A Review on the Report by Bureau Veritas on
Investigation of distress in basement floor and terrace level overhead tanks of
Army Welfare Housing Organisation “Chanderkunj Army Towers”
at Silver Sand Island, Vytilla, Kochi, Kerala (November 2020)

**Review of the report by Bureau Veritas (dated Dec 3, 2020) for
Chander Kunj Apartments, Silver Sand Island, Vytilla, Kochi**

Table 1: Specific comments on inferences in BV Report

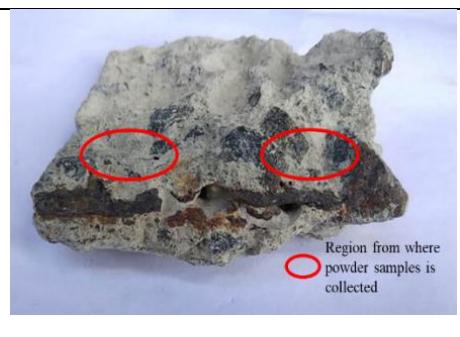
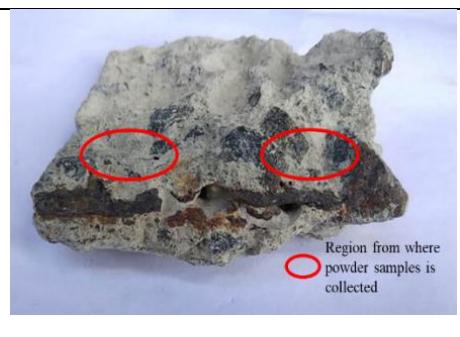
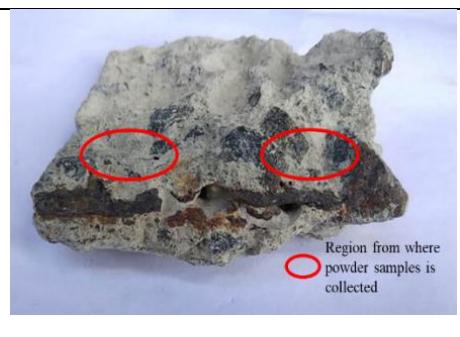
Table 1 provides my responses/suggestions against all the inferences in the BV Report. Also, the recommendations made in the BV Report are inadequate to achieve a service life of multiple decades with minimal maintenance and without major/repeated repairs. **Please arrange to conduct more tests and data analysis as suggested in Table 1 and revise the Sections D, E, F, and G of the BV Report.** Also, the collected data should be assessed in a quantitative manner, wherever possible. The submitted BV report do not comment on the corrosion and chloride conditions of the members that exhibited and are exhibiting corrosion/cracking. The revised report must reflect these. Note that Item 6 in Table 1 shows that the chloride contents (from the tests conducted at IIT Madras) in the concrete samples supplied is higher than the allowable chloride content of 0.6 kg/m³ (as per IS 456).
